City of Portland, Oregon
Bureau of Development Services
Land Use Services
FROM CONCEPT TO CONSTRUCTION

MEMORANDUM

Date: April 24, 2018
To: Bronson Graff and Isaac Johnson, Ankrom Moisan Architects
Stephen Goodman, LMC
From: Tanya Paglia, Development Review
503-823-4989
Re: EA 18-129788 DA – 815 W Burnside/Firestone Site
Design Advice Request Summary Memo April 19, 2018

This memo summarizes **Design Commission** design direction provided on April 19, 2018.

SOUTH ELEVATION

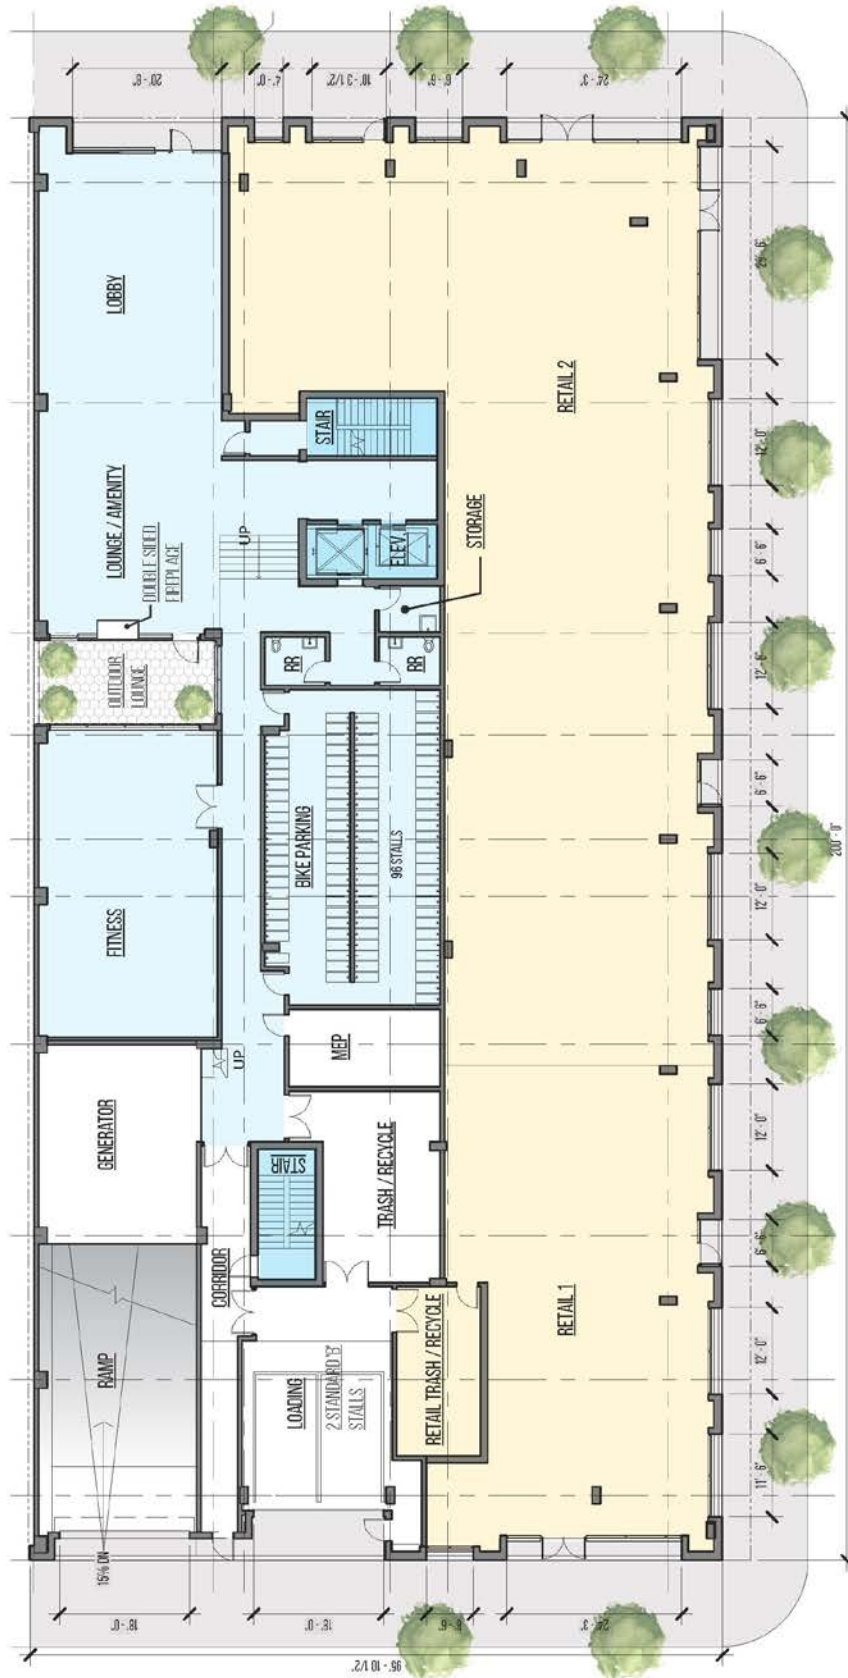
- The Burnside elevation’s ground floor should be more transparent. There are too many piers and the niches for entrances should be wider. Careful consideration should be given to the canopies on the Park Blocks frontage which can contribute identity to the building.

- Burnside Elevation:
 - The ground floor should be more transparent. There are too many piers and the niches for the entrances should be wider.
 - Addressing the compressed ground floor issue and verticality issues identified earlier with a two-story expression could make the Burnside frontage more inviting.

- The building should stand its ground against the fortress-like building across W Burnside, but without echoing the pedestrian unfriendly traits of that building.

- Softening an edge can do a great deal for street life. Consider inventive options on Burnside (example given of slanted entries at “Good Dog Bad Dog” formerly located at 708 SW Alder St).

EAST ELEVATION
1/8" = 1'-0"

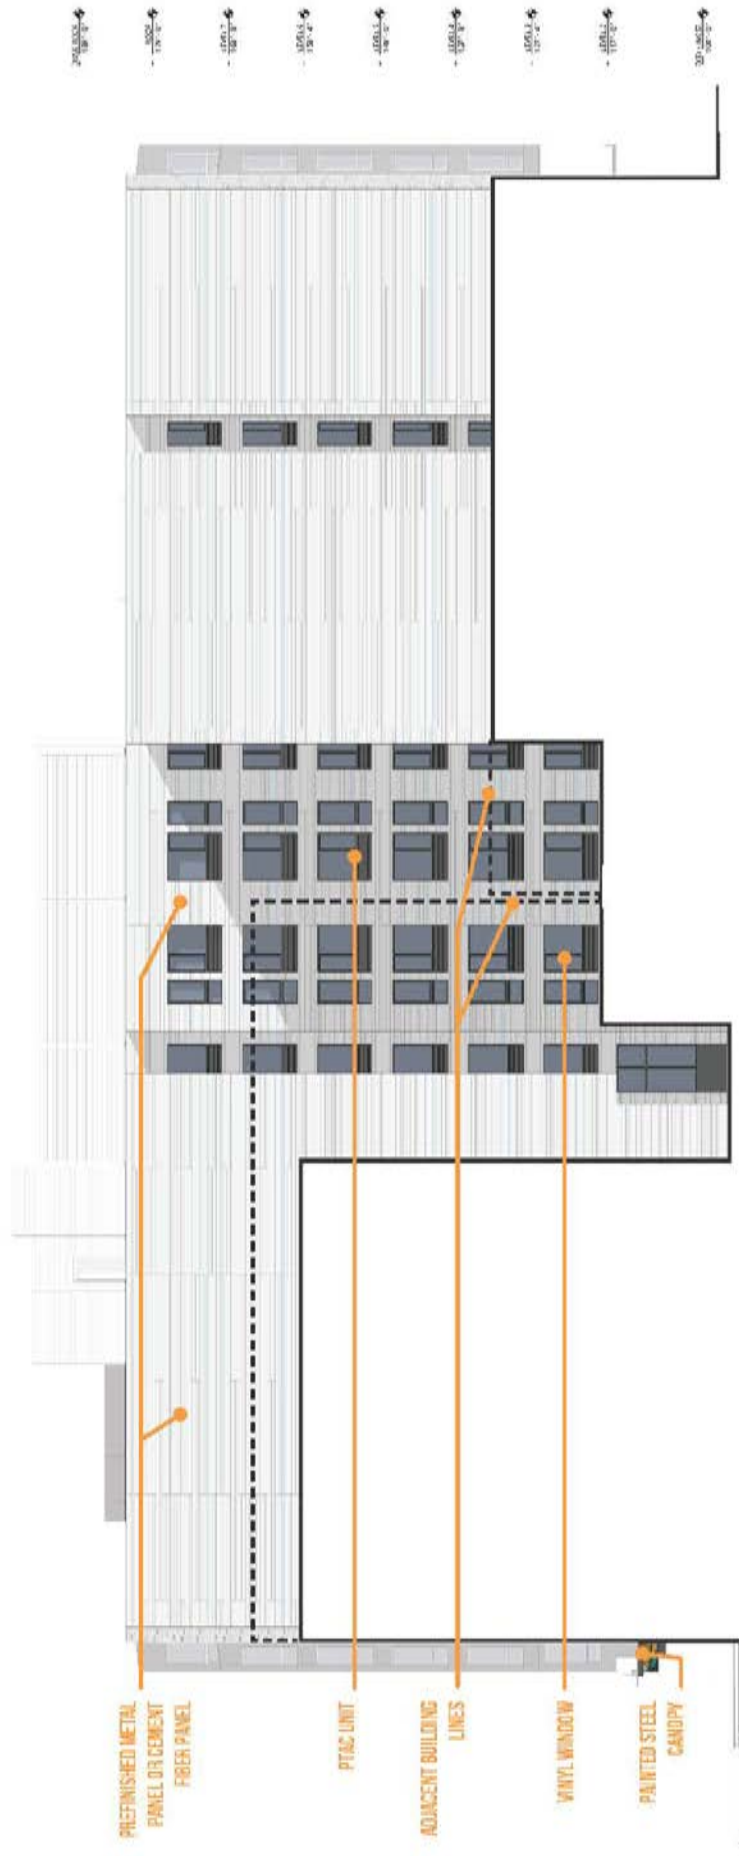
- Park Blocks Elevation:
 - As previously noted, balconies facing the Park Blocks would activate this façade and help the building’s relationship with the park. A larger communal outdoor amenity space instead of individual balconies could also be successful.

- Revisions made to the ground floor of the Park Blocks frontage between the time the packets were printed and when the DAR was held were moving in the right direction.

- Careful consideration to the canopies should be given as the Park Blocks frontage continues to develop. The right canopies could add a great deal to the specialness of the elevation facing the park.
